# BOERNE STAGE FIELD SUBDIVISION PUD PLAN

BOERNE STAGE FIELD  
BEXAR COUNTY, TEXAS  
P.U.D. PLAN

**SUBJECT:** PUD# 06-011

**Name:** Boerne Stage Field Subdivision

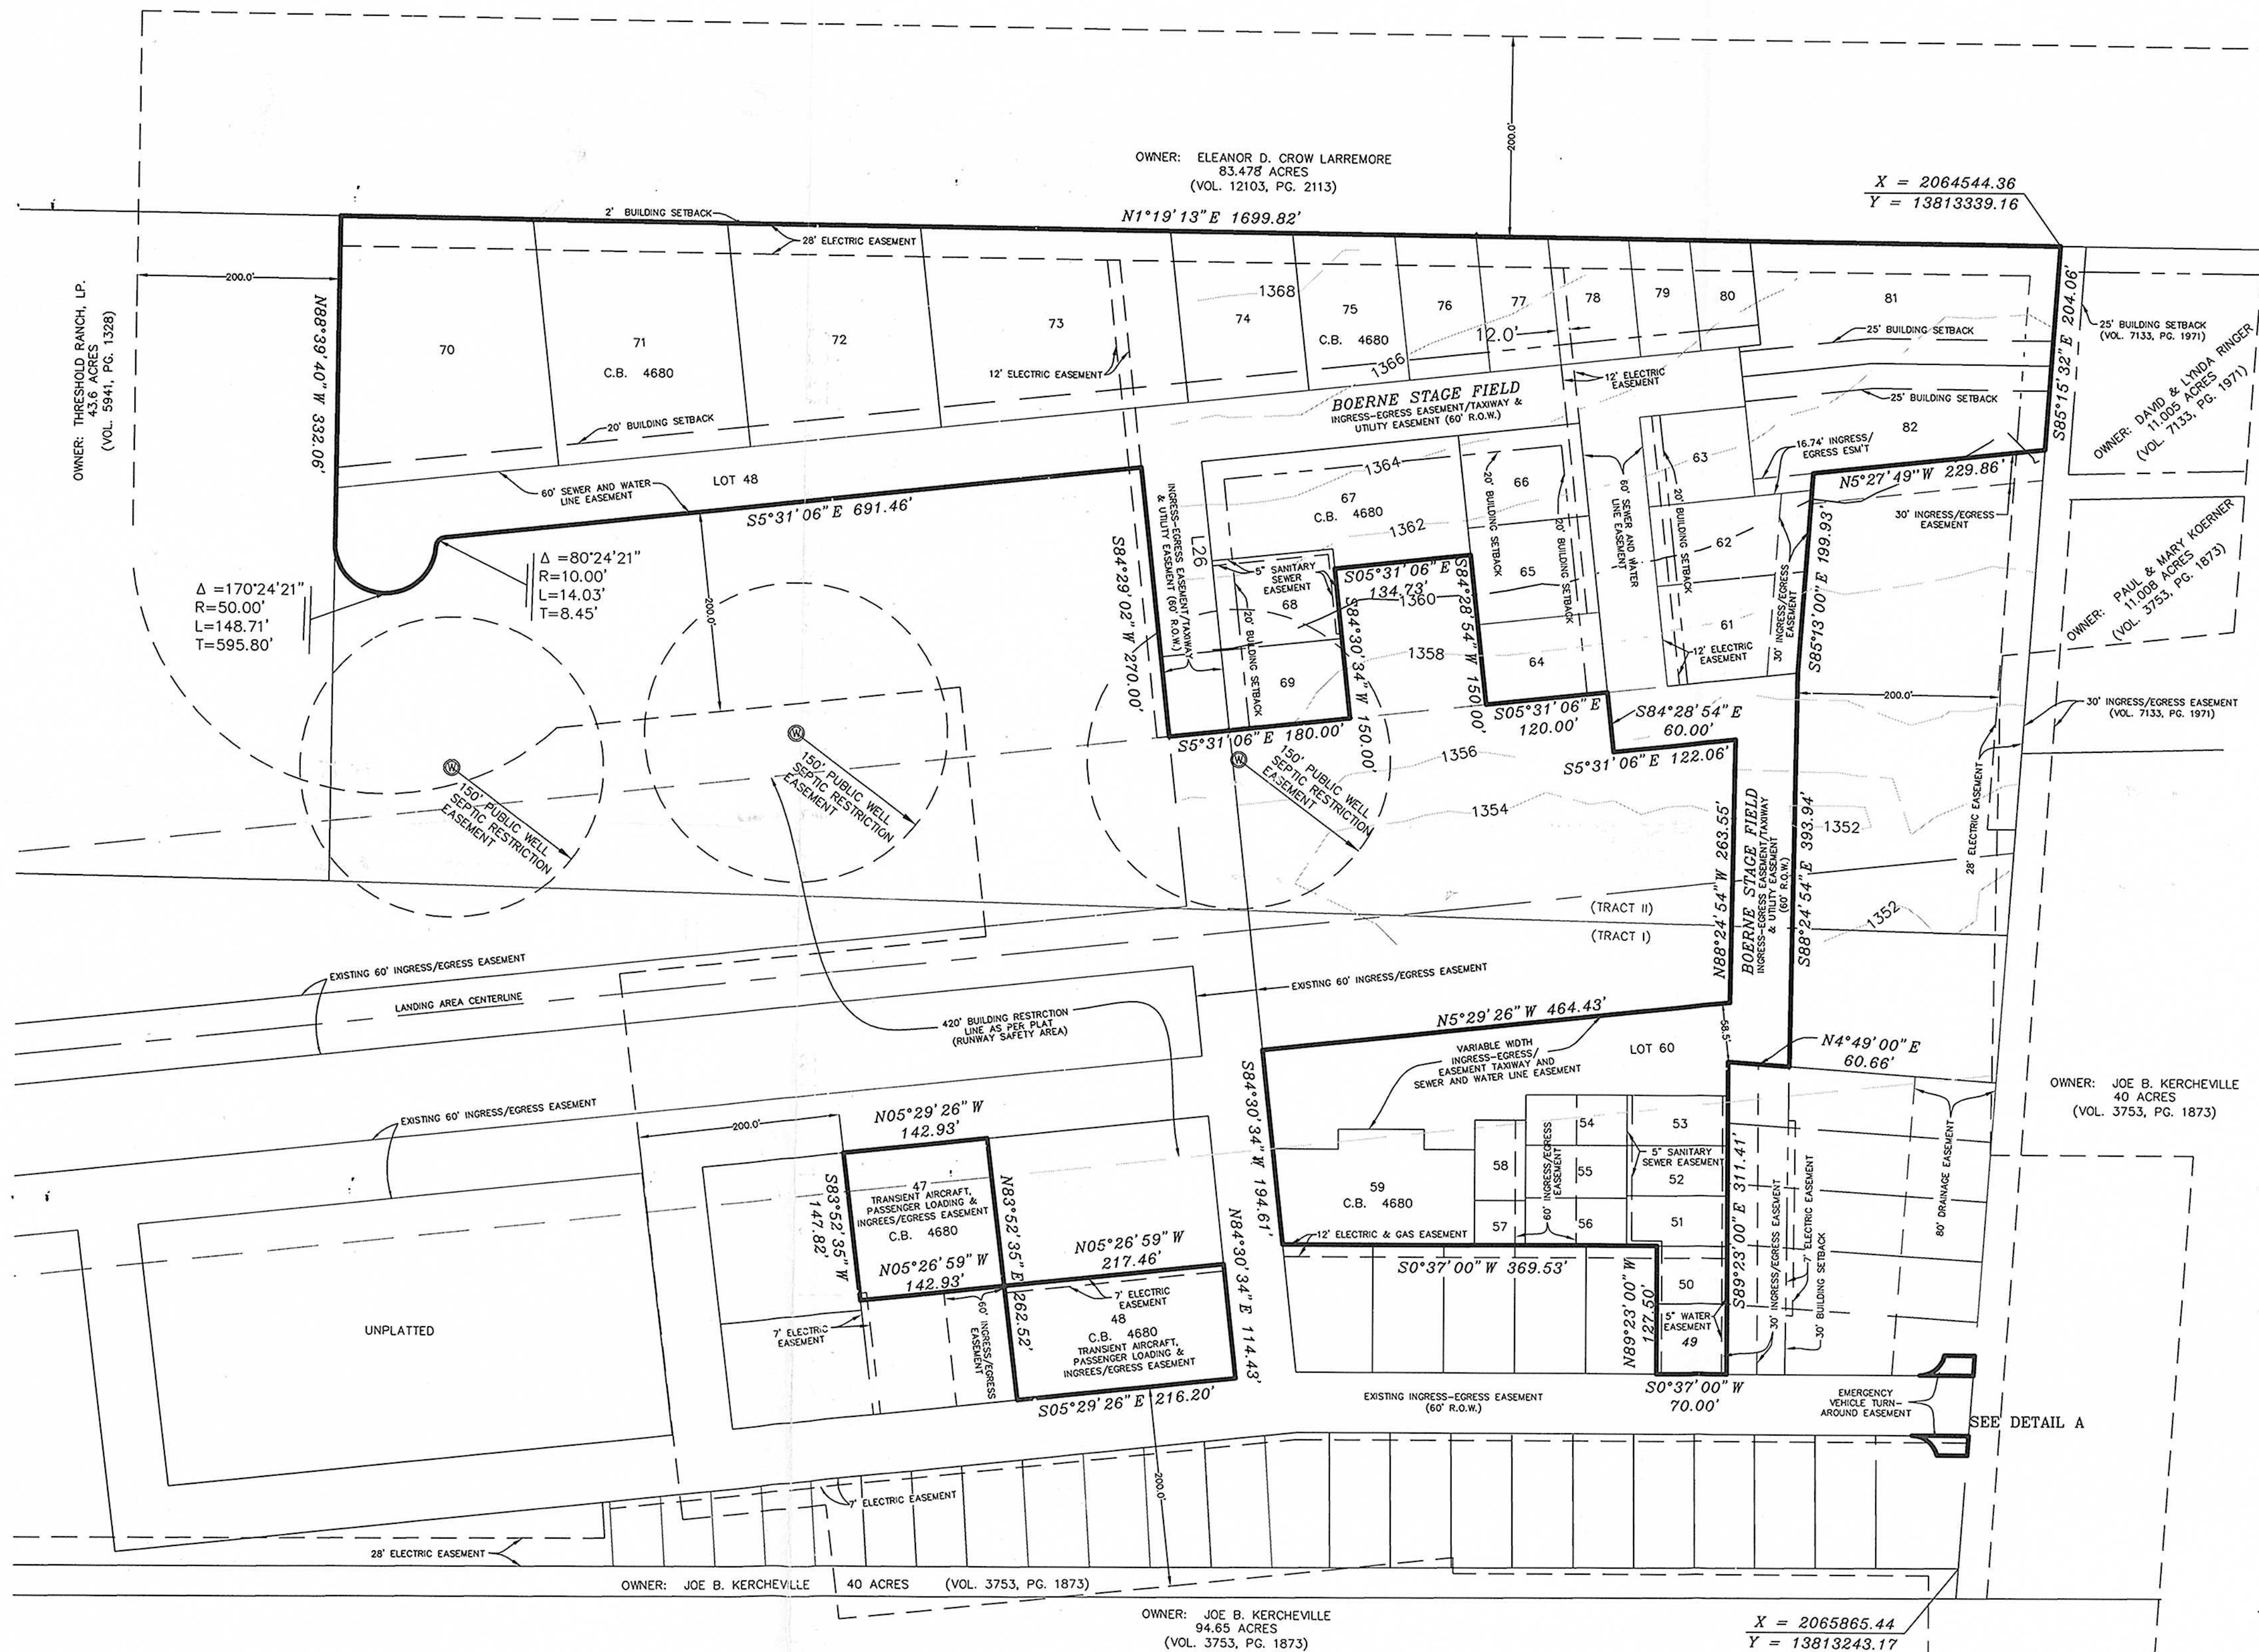
The dedicatory instrument(s) (Legal Instrument) for common areas and facilities must be approved by the City Attorney as to legal form prior to any plat recordation and shall be recorded at the same time as the plat. UDC 35-344(i)

**DSD – Traffic Impact Analysis & Streets** indicates the following requirements and onsite improvements that are necessary and shall be provided by the developer, on and before the completion of Boerne Stage Field Subdivision PUD, at no cost to the City of San Antonio:

- All roadways shall follow Table 506-7, Functional Classification System Description and shall comply with UDC 35-502 (a)(9).
- All access roadways shall provide clear sight distance and all signage, landscaping, and improvements shall be located so as to not to block clear sight distance.
- All commercial driveways for this project shall comply with UDC 35-506 (r) Access and Driveways.
- Sidewalks along interior and exterior are to be installed in accordance with UDC 35-506 (q).

- Boerne Stage Field is a proposed commercial subdivision. UDC Section 35-344(g)(2) states that all commercial and industrial PUD plans must contain a minimum 20% open space. This subdivision provides 57 % open space.
